STAFF REPORT

SUBJECT: H-2020-0127
Skybreak Subdivision

LOCATION: 7020 S. Eagle Rd. & 3487 E. Adler Hof Ln., in the south ½ of the NW ¼ of Section 4, T.2N., R.1E. (Parcels # S1404244250 & S1404233650)

E. Gated versus Non Gated (date: 2/11/2020)

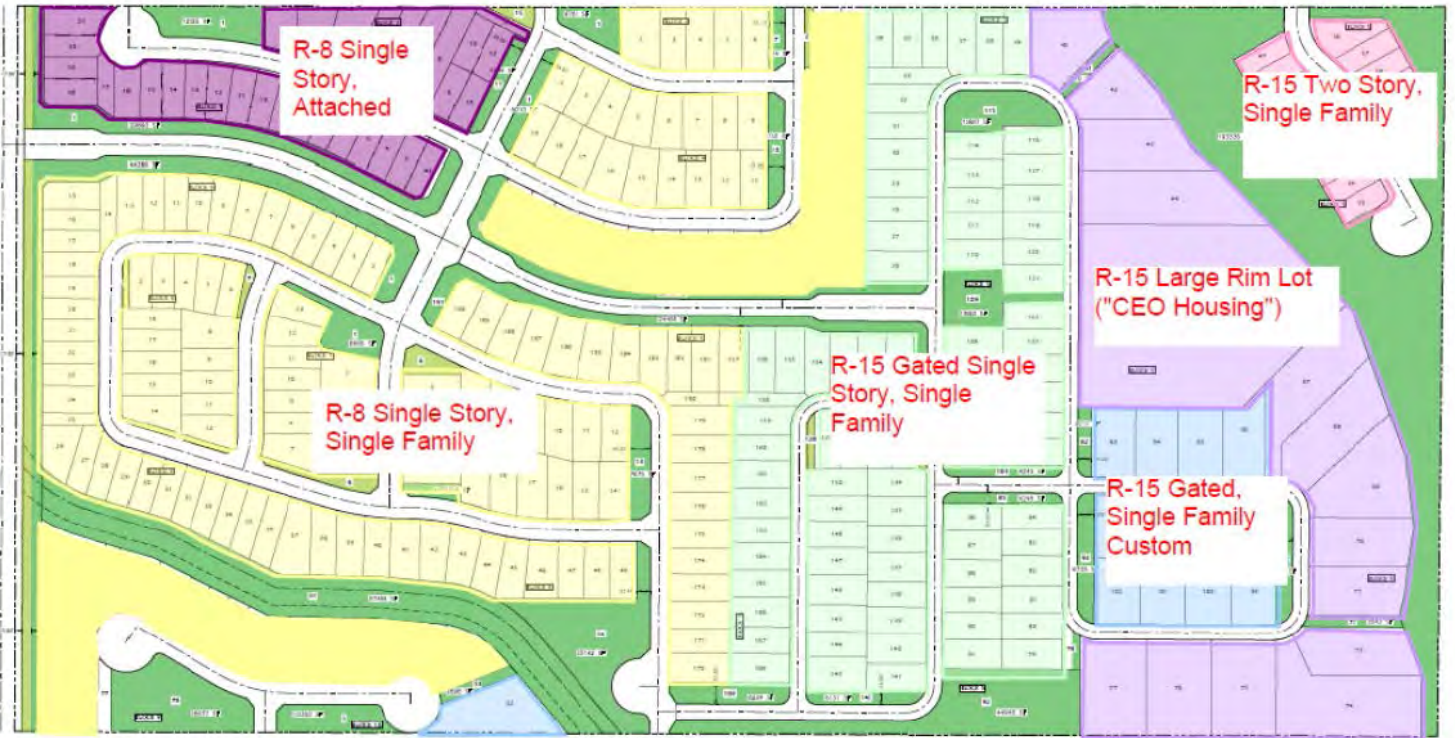
The applicant proposes 112 gated lots, and 3 common driveways off a private street. UDC 11-3F-4 states a proposed (gated) development shall have no more than 50 dwelling units, and no common driveways shall be allowed off of a private street. However, 11-3F-4 also allows the director to approve, or recommend approval of alternative design or construction standards when the applicant can demonstrate that the proposed overall design meets or exceeds the intent of the required standards of this article and shall not be detrimental to the public health, safety, and welfare.

The applicant's alternative compliance letter mentions there is a demographic of senior home buyers that prefer the security a gated community can provide and that the gates and private streets will provide a more intimate setting. Staff agrees that there is probably a demographic that would prefer gated communities, but this is not a condition required for alternative compliance. The Director finds the applicant has not demonstrated the need for a private versus public streets as noted above.

The plat indicates private street sections with no sidewalks and minimal landscaping, whereas ACHD templates require 5' sidewalks and landscaping. Also, the applicant proposes alternative compliance to allow three common driveways from the private streets, whereas this is not allowed by UDC 11-3F-4-6. Staff does not understand how what is being proposed is an equal or superior means to meeting requirements. Providing narrow private streets with no sidewalks, minimal landscaping, and common driveways from these private streets is not an innovative design features that promotes walkable neighborhoods.

Finally, as was already mentioned, gating the community will also slow response times when there are already fire access concerns, which would be materially detrimental to the public welfare.
